Appendix I of RNTPC Paper No. A/YL-PH/1036

# UNDER SECTION 16 OF THE TOWN PLANNING ORDINANCE

劃資料查詢處供一般參閱。)
Application No. 申請編號	(For Official Use Only) (請勿填寫此欄)
Location/address 位置/地址	新界元朗八鄉七星崗DD110 LOT NO. 247(部份), 249, 250(部份), 251S.A RP(部份), 251S.B(部份), 262(部份), 263S.A&S.B&S.C(部份), 264(部份), 265, 266(部份), 267(部份), 269(部份), 269(部份), 270S.E(部份), 272, 273S.A, 273S.B, 274, 275, 276RP(部份), 277, 278, 279S.A, 279S.B, , 280, 281(部份), 285, 286, 287, 295, 299
Site area 地盤面積	30211 sq. m 平方米口 About 約
	(includes Government land of 包括政府土地 N/A sq. m 平方米 □ About 約)
Plan 圖則	S/YL-PH/11
Zoning 地帶	農業
Type of Application 申請類別	<ul> <li>✓ Temporary Use/Development in Rural Areas or Regulated Areas for a Period of 位於鄉郊地區或受規管地區的臨時用途/發展為期</li> <li>✓Year(s) 年3 □ Month(s) 月</li> <li>□ Renewal of Planning Approval for Temporary Use/Development in Rural Areas or Regulated Areas for a Period of 位於鄉郊地區或受規管地區臨時用途/發展的規劃許可續期為期</li> </ul>
	□ Year(s) 年 □ Month(s) 月
Applied use/ development 申請用途/發展	擬議臨時貨倉(危險品倉庫除外)及露天存放建築機械和建築材 料連附屬設施(為期3年)及相關填土工程

#### **Response to Comment**

Figure 1	Location Plan
Figure 2	Proposed Development Layout
Figure 3	Catchment Areas
Figure 4	Stormwater Drainage Management Plan
Figure 5	Details of Outfall

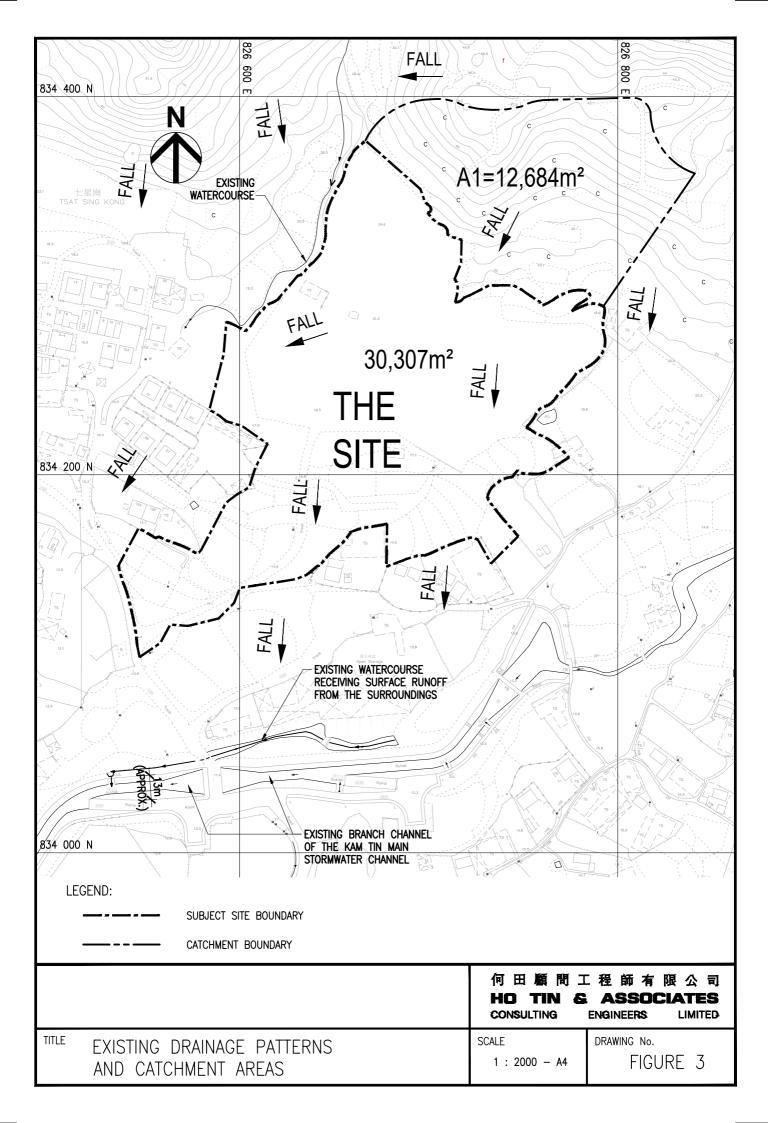
- (ii) Figure 4 indicated that peripheral surface channels with be provided along the site boundary. The other drainage channels with the Site, if any, should be shown;

- (iii) in accordance with the calculation enclosed in the Appendix, the flow path to demonstrate how the surface runoff can be intercepted into the proposed channels should be shown. The proposed site formation levels in Figure 4/surface run off drawing etc. should be shown for further comment;

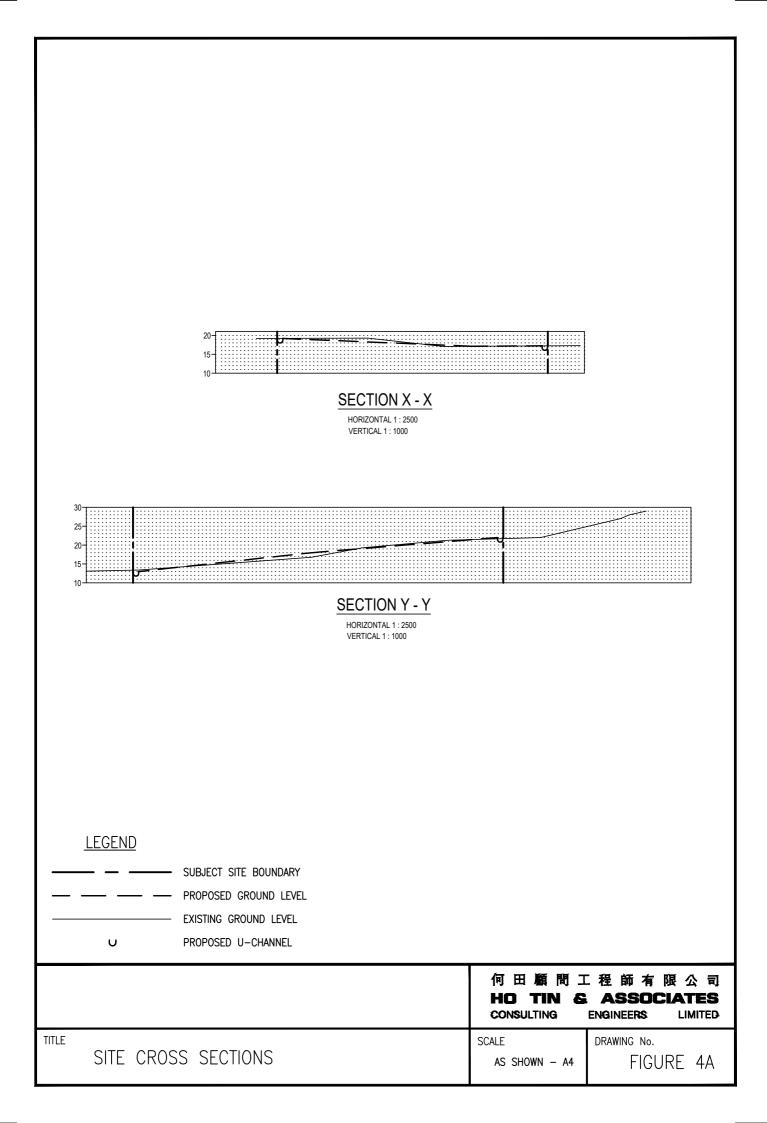
- (iv) the C.L, I.L and bottom level at discharge point shown in Figure 5 should be indicated;
- (v) where walls or hoarding are erected or laid along the site boundary, adequate opening should be provided to intercept the existing overland flow passing through the Site;

Tree Schedule, Tree Survey Plan

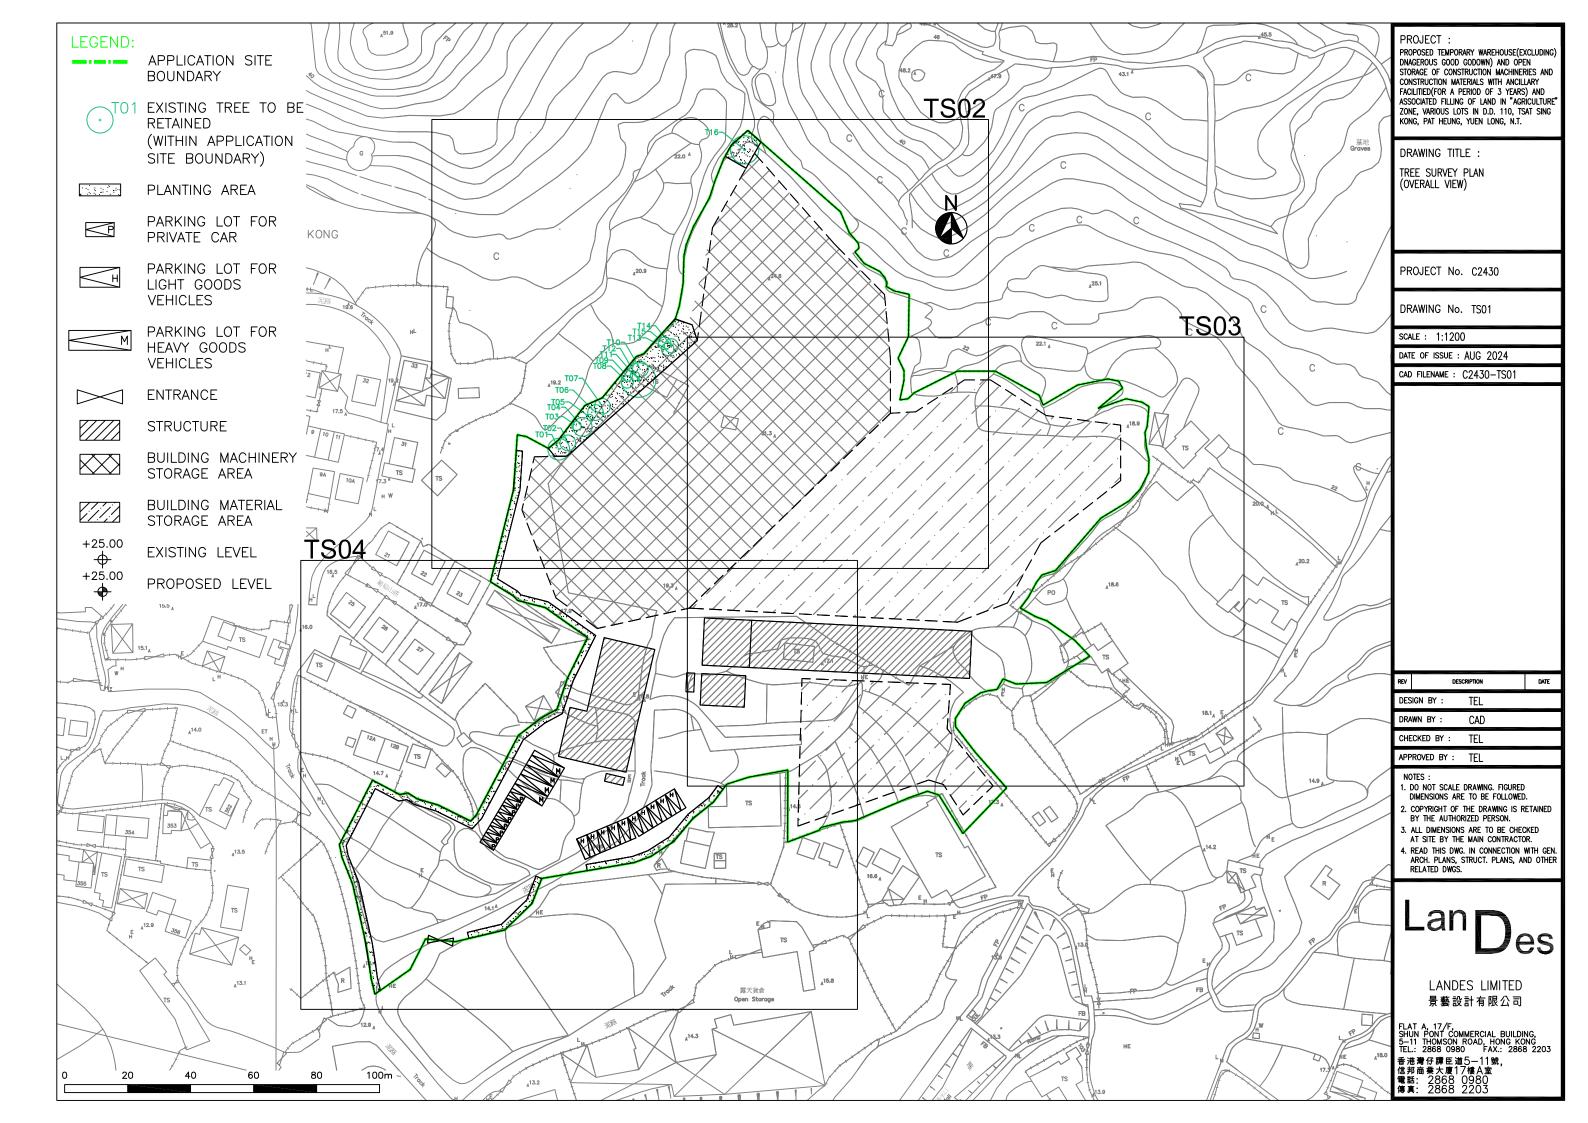
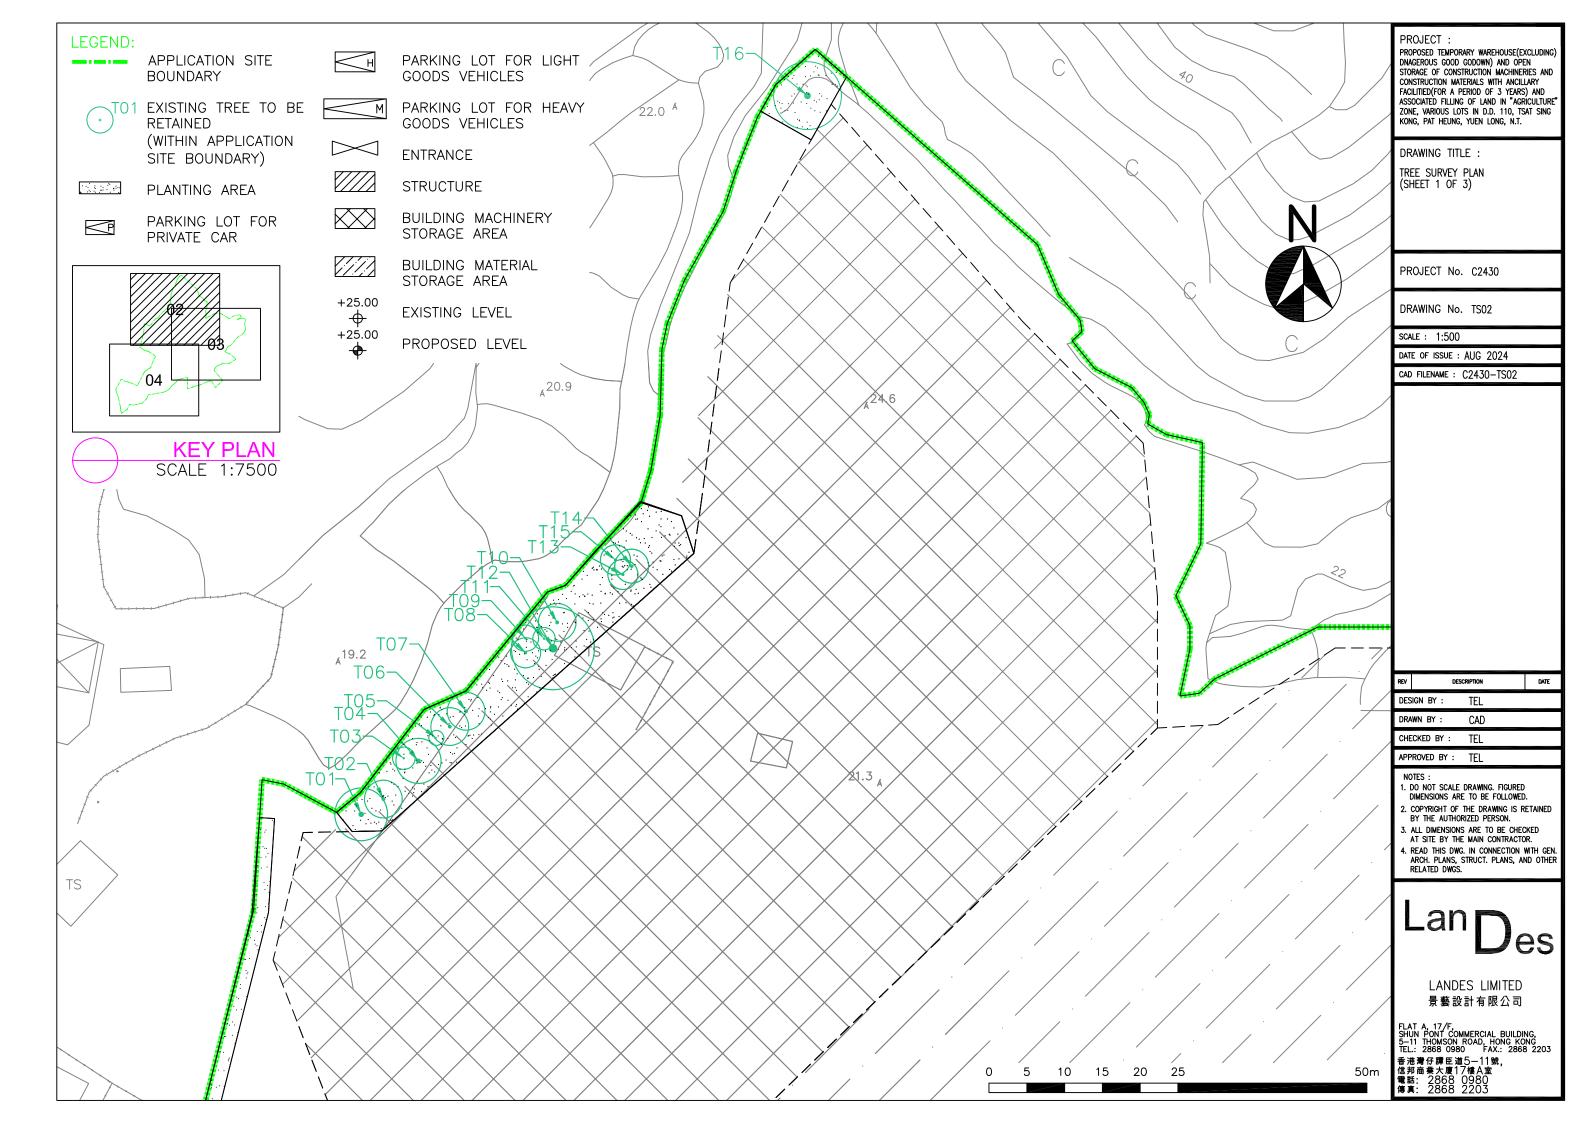
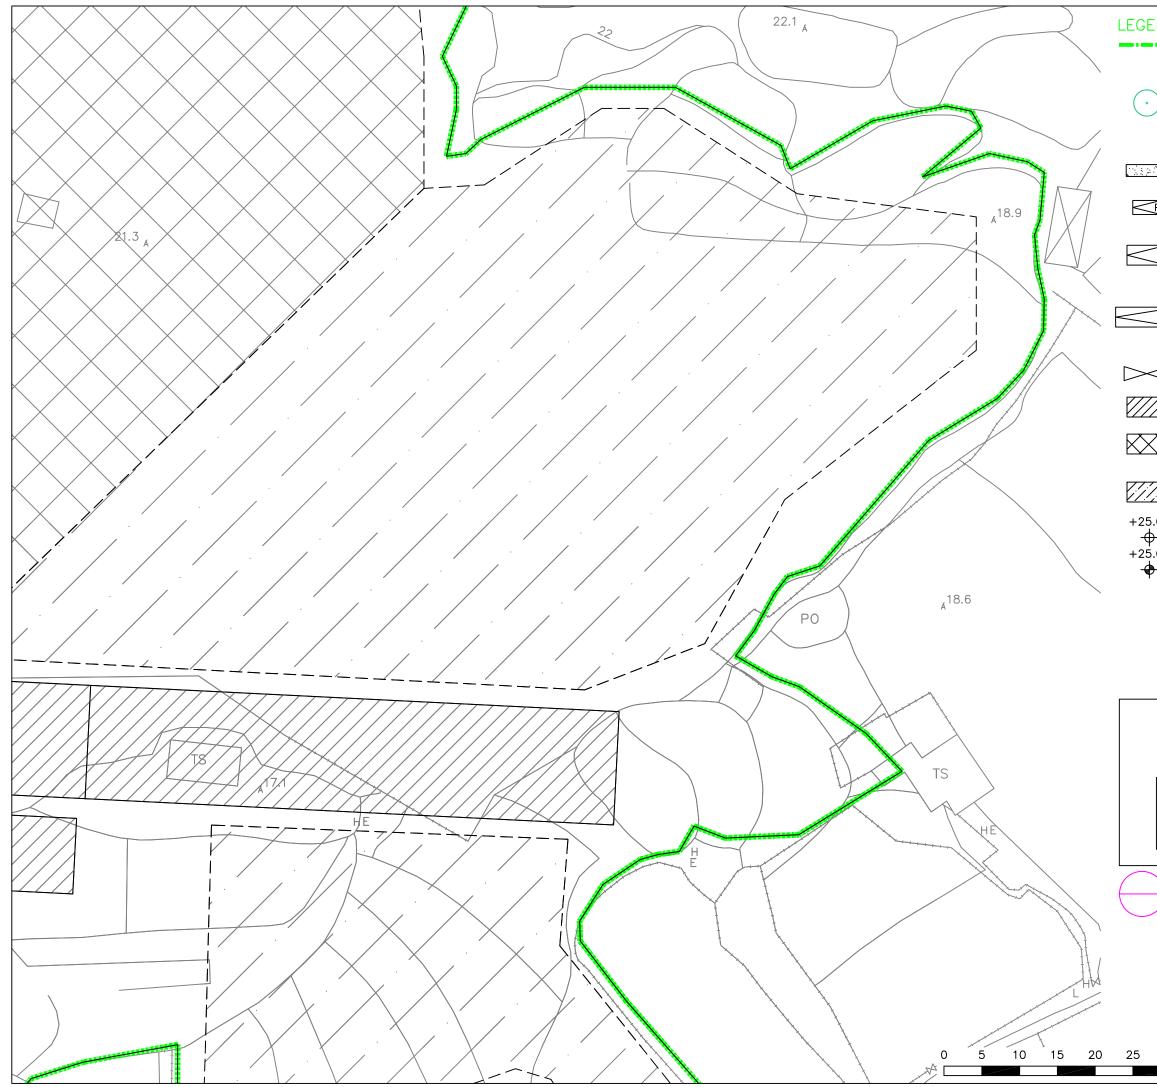
Comments from the Landso	cape Unit, Planning D	<u>epartment</u> (Contact Pe	erson: Mr Henry NG at Tel. 3565 3950)			
Comment:			Response:			
(1) With reference to the si	ite visit in November	2024, some trees are	To clarify, there are only weeds and undersized trees observed in the			
observed on the new ar	reas included in the c	urrent application.	new areas.			
Nevertheless, no existir	ng tree is recorded wi	thin the new areas in				
the submitted Tree Pres	servation and Landsca	ape Proposal (TPLP).	Besides, as there are 13 missing trees on Site, additional trees are			
Moreover, the following	g differences betweer	n the last approved	proposed to compensate for the loss of greenery. It is proposed			
application and the cur	rent application are n	oted. The applicant	that 96 new trees (83 trees mentioned in previous application + 13			
should clarify the different	ences/discrepancies	as appropriate.	missing trees) will be planted within Application Site.

4.6 As compared to Application No. A/YL-PH/960, there should be 29 trees to be retained on Site but only 16 trees were surveyed in the current submission. Besides, it was proposed that 83 new trees would be planted in the previous application. In order to compensate for the loss of greenery, it is proposed that 96 new trees, i.e. 83 new trees mentioned in previous application and 13 missing trees, will be planted within Application Site.
